PAPWORTH EVERARD PARISH COUNCIL

Response to SCDC application No: **S/1509/12/VC**

Proposal: **s73 application for variation to Condition 23 of planning approval S/2167/11**

Location: **Summersfield, part of Phase 3 (Plots D167 to D426). Papworth Everard, Cambridgeshire**

'Langdale' Plot 218

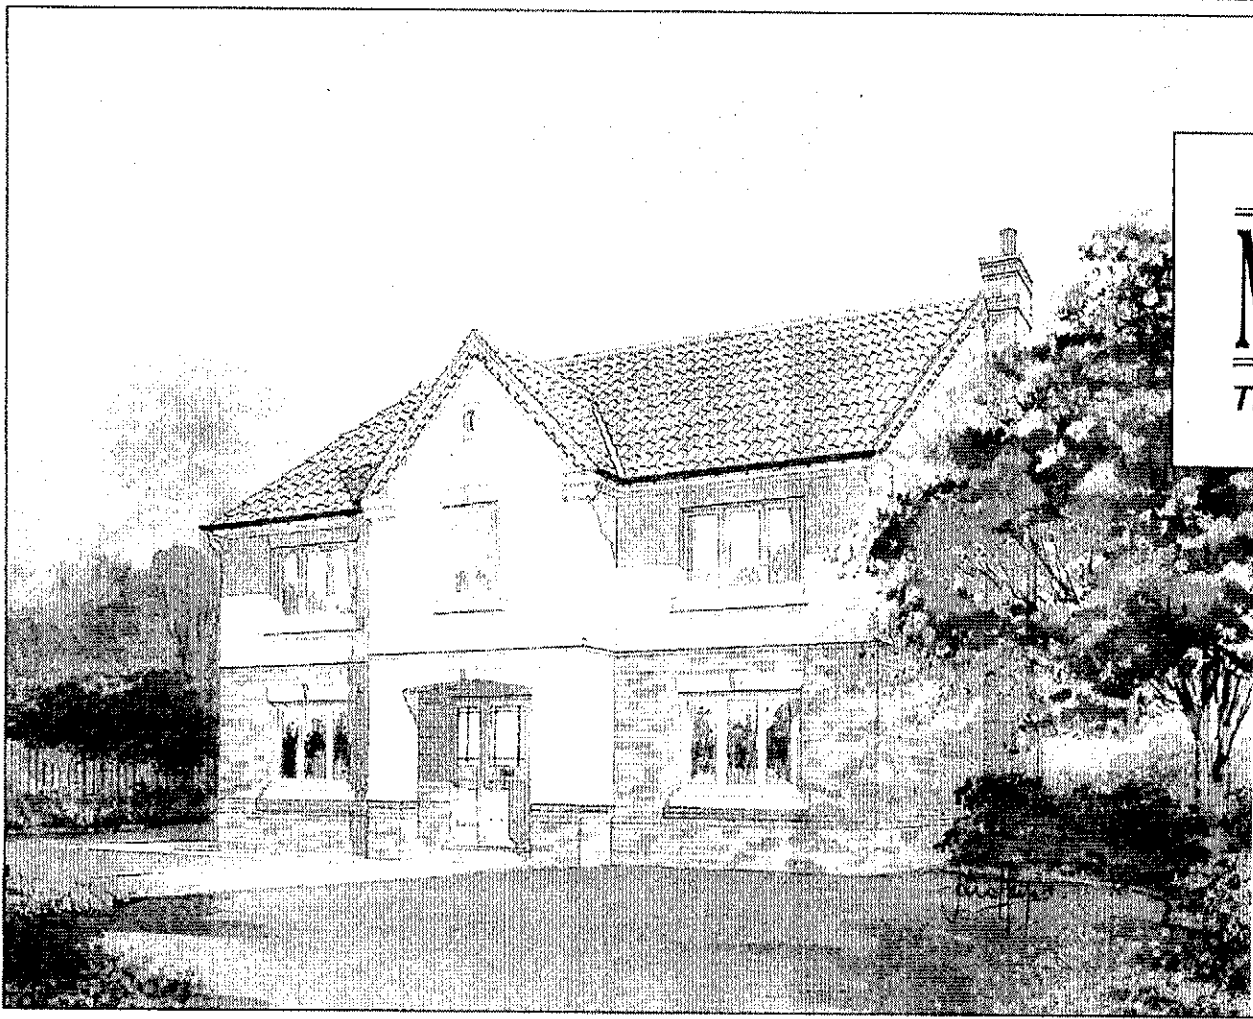
6-panelled door is too elaborate for this small house type – replace with four-panelled, or 'cottage' type. Bay window does not sit comfortably on this house type. Remove the incised rendering to the lower storey.
